Access Compliance Report

Public Rights-of-Way

(Curb Ramps)

Intersection ID: 26423	Main Street: BEVINGTON_PL	Cross Street: SILVER_PINE_DR	Location: NW
ADA ID: 68D8926567A6	Ramp Type: PerpDiag	Initial Pass/Fail: Fail	Overall Compliance: No
		Severity Score: 12.5

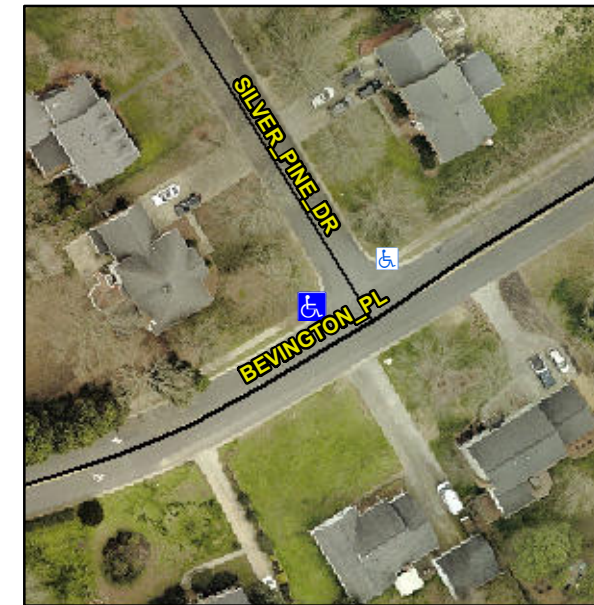
R304.5.3

Compliance	Description	Data	Compliance	Description	Data
N/A	Ramp Length (in)	42.0	Yes	Ramp Slope (%)	6.6
Yes	Ramp Width (in)	48.0	No	Ramp XSlope (%)	6.1
N/A	Flare Type LT	N/A	N/A	Flare Type RT	N/A
N/A	Flare Slope LT (%)	N/A	N/A	Flare Slope RT (%)	N/A
N/A	Flare Traversable LT?	N/A	N/A	Flare Traversable RT?	N/A
N/A	Landing Length (in)	N/A	N/A	DWS Provided?	N/A
N/A	Landing Width (in)	N/A	N/A	DWS Contrast?	N/A
N/A	Landing Slope (%)	N/A	N/A	DWS Length (in)	N/A
N/A	Landing X Slope (%)	N/A	N/A	DWS Full Width?	N/A
N/A	Landing Curb? (Y/N)	N/A	N/A	DWS Offset (in)	N/A
N/A	Shared Landing?	N/A			
N/A	Gutter Ponding?	N/A	N/A	Gutter Slope (%)	N/A
N/A	Gutter Lip Ht (in)	N/A	N/A	Gutter X Slope (%)	N/A
N/A	Painted X Walk1?	No	N/A	Painted X Walk2?	No
	X Walk 1 Direction	To SE		X Walk 2 Direction	To NE
N/A	X Walk 1 Width (in)	N/A	N/A	X Walk 2 Width (in)	N/A
	X Walk 1 Slope (%)	8.2		X Walk 2 Slope (%)	0.6
	X Walk 1 X Slope (%)	0.4		X Walk 2 X Slope (%)	5.0

Remove & Replace Curb Ramp With Two New Directional Ramps or Equivalent.
